Report: ISSUE REPORT
Function: Test, Adjust, & Balance
Date: 02/08/2024

PROJECT
02-05-24 PERRY'S - VERNON HILLS, IL

Issue List

Speedtaps
02/08/2024

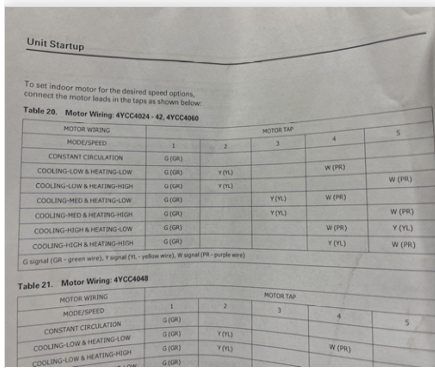
Issue Name : RTU-4: High on airflow
Description : RTU-4 is multispeed unit scheduled for 600cfm with speed taps. Plans call for constant volume. Unit is within design at Speed tap 1, where G is landed. Manual indicates placing W(heat) at 4 and Y (cool) at tap 2, puts heating and cooling to low speed, this is 940cfm. Not possible to wire all stages to same speed. No indication if jumpers are allowed.

RTU_5
02/08/2024

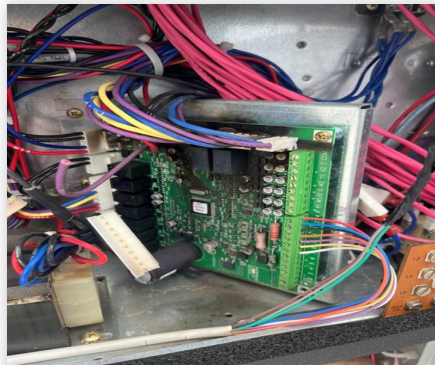
Issue Name : RTU-5: Not Operational
Description : RTU-5 is not operational as the control board is fried. Waiting on replacement board. Unit not yet balanced as result.
Created By : National TAB **Assigned To :** National TAB - Michael McDonnell
Status : Open
Priority : **Urgent** **Asset Tag :**
Originated Date : 02/08/2024 - Michael McDonnell - National TAB

- **02/15/2024 National TAB - Michael McDonnell**
 - Trane Service was on site 2/14/24 to replace the board. They were unable to get the unit running.
